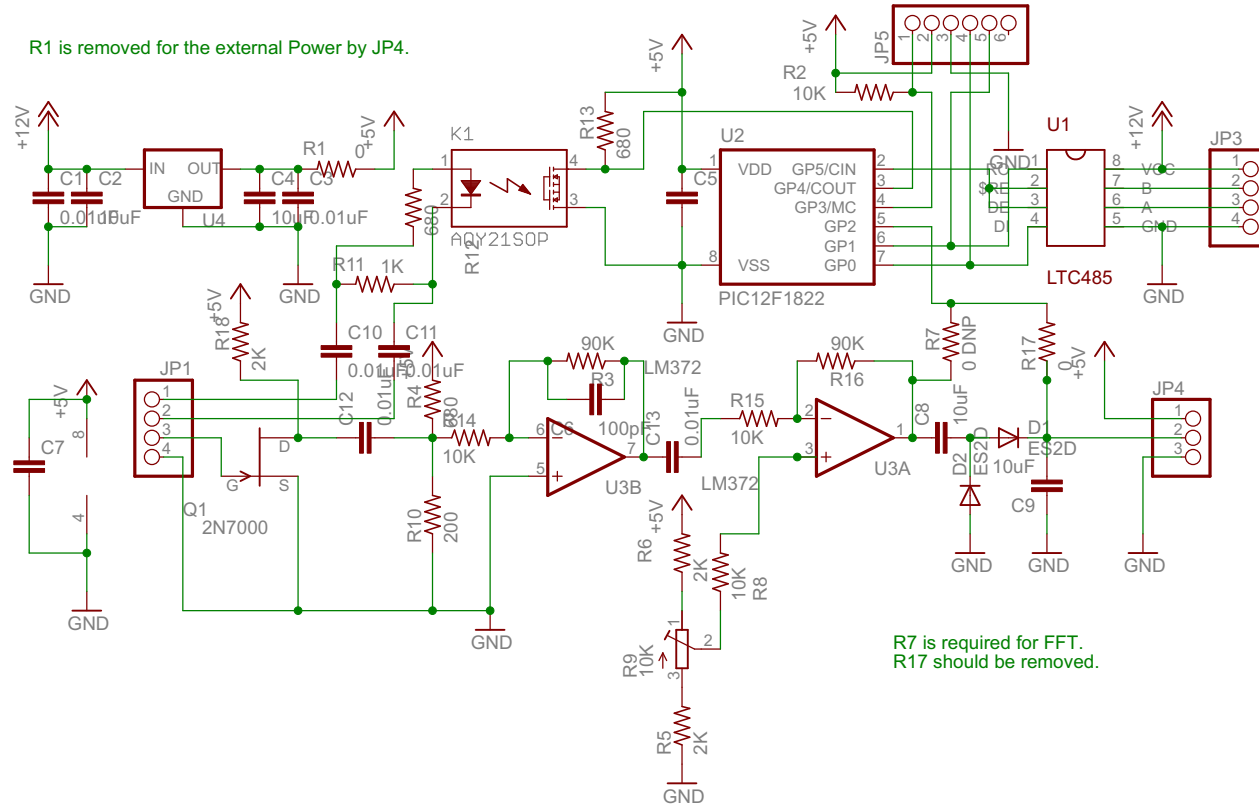
R1 is removed for the external Power by JP4.

R7 is required for FFT.
R17 should be removed.
